**RE: BODY SERIAL  
CHASSIS SERIAL**

# INSTRUCTIONS TO PERFORM CAMPAIGN 123

2012 model year Winnebago Industries Era® (Model 170X) motor homes.

**Incorrect Water Weight Caution Label (Label 1)**

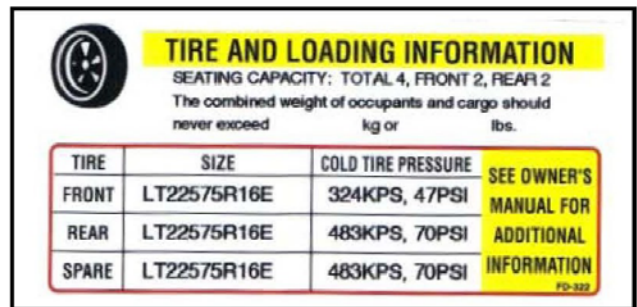
The affected vehicles were produced with incorrect Vehicle Weight Information Labels located along side the driver door frame (Labels 1 and 2). These labels must be removed and replaced with the correct one (Label 3).

1. Remove and discard existing Water Weight Caution Label (Label 1). See Photo A.

3. Cover the existing black Tire Inflation Pressure Label with the correct Occupant and Cargo Carrying Capacity Label (Label 3). See Photo D.

**Incorrect Tire and Loading Information Label (Label 2)**

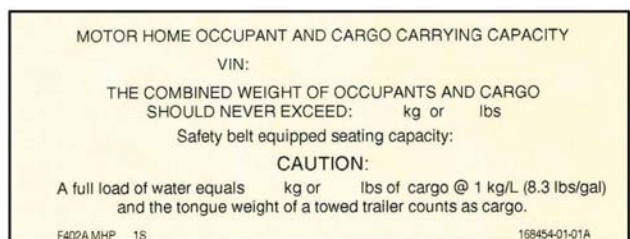
2. Remove and discard existing Tire and Loading Information Label (Label 2), which will reveal the chassis manufacturer's black Tire Inflation Pressure Label. See Photos B and C.
